NRC 2006-0033
10 CFR 50.90

Point Beach Nuclear Plant, Units 1 and 2
Dockets 50-266 and 50-301
License Nos. DPR-24 and DPR-27

License Amendment Request 245:
Technical Specification 3.3.4, Loss of Power Diesel Generator Start Instrumentation

LICENSE AMENDMENT REQUEST 245 TECHNICAL SPECIFICATION 3.3.4, LOSS OF POWER DIESEL GENERATOR START INSTRUMENTATION

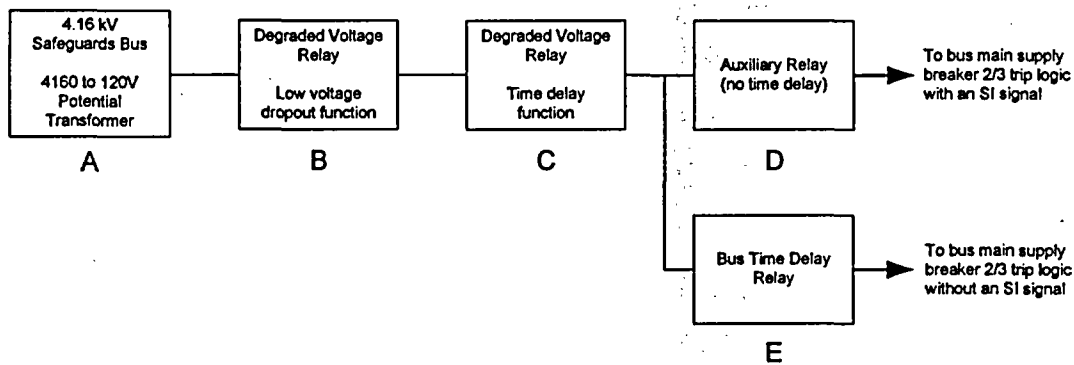
Degraded voltage protection on each 4.16 kV safeguards bus is provided by three degraded voltage channels, each with a degraded voltage relay having voltage and time delay settings and a bus time delay relay having a separate time delay setting. Each degraded voltage channel is configured as shown in the figure below:

Blocks A through D above provide degraded voltage protection coincident with an SI signal. When an SI signal is present and safeguards bus voltage remains below approximately 95% of nominal voltage as detected by a potential transformer (Block A), the degraded voltage relay (Block B) drops out and begins its time delay (Block C). After timeout, the degraded voltage relay output (through Block D) is combined with the other degraded voltage channels in a two-out-of-three coincidence logic to generate a bus main supply breaker trip. Opening the breaker disconnects the bus from offsite power, creating a loss of voltage condition on the bus. The bus loss of voltage function will then initiate DG start.

Blocks A, B, C, and E provide degraded voltage protection without an SI signal present. With no SI signal present and safeguards bus voltage sustained below approximately 95% of nominal voltage, the degraded voltage relay times out first, after which the bus time delay relay (Block E) times out. After timeout, the relay output is combined with the other degraded voltage channels in a two out of three coincidence logic to generate a bus main supply breaker trip. Opening the breaker disconnects the bus from offsite power, creating a loss of voltage condition on the bus. The bus loss of voltage function will then initiate DG start.

The time delay Allowable Value now labeled "with SI signal present" is revised downward from < 6.47 seconds to < 5.68 seconds, to account for a reanalysis of degraded voltage occurring on the 4.16 kV safeguards buses coincident with a loss of coolant accident. When an SI signal is present, the only time delay function in the channel is performed by the degraded voltage relay. Therefore, the Allowable Value is used to determine degraded voltage relay operability and the appropriate nomenclature for this Allowable Value is

The total degraded voltage circuitry time delay when no SI signal is present is the sum of two time delays, one from the degraded voltage relay and the other from the bus time delay relay. The present time delay Allowable Value (< 54 seconds without SI signal present) represents the combined time of both relay time delays. Since the degraded voltage relay time delay is addressed by the specific Allowable Value discussed above, the second Allowable Value (without SI signal present) is being revised to apply specifically to the bus time delay relay. With this change, both Allowable Values can be more readily evaluated directly against the relays' as-found performance to determine operability.

The time delay Allowable Value presently labeled "without SI signal present" is revised downward from < 54 seconds to < 39.14 seconds. This reduction accounts for both a reanalysis of degraded voltage occurring on the 4.16 kV safeguards buses during normal plant operation and the reassignment of the second Allowable Value specifically to the bus time delay relay, rather than representing a combined time delay from the two relays in series. The appropriate nomenclature for the revised Allowable Value is "bus time delay relay", to identify the specific device to which the Allowable Value applies.

- b. 4.16 kV degraded voltage Allowable Value
 - ≥ 3937 V with a time delay of
 - < ~~6.47~~ 5.68 seconds (~~with SI signal present~~ bus degraded voltage relay) and
 - < 54 ~~39.14~~ seconds (~~without SI signal present~~ bus time delay relay)
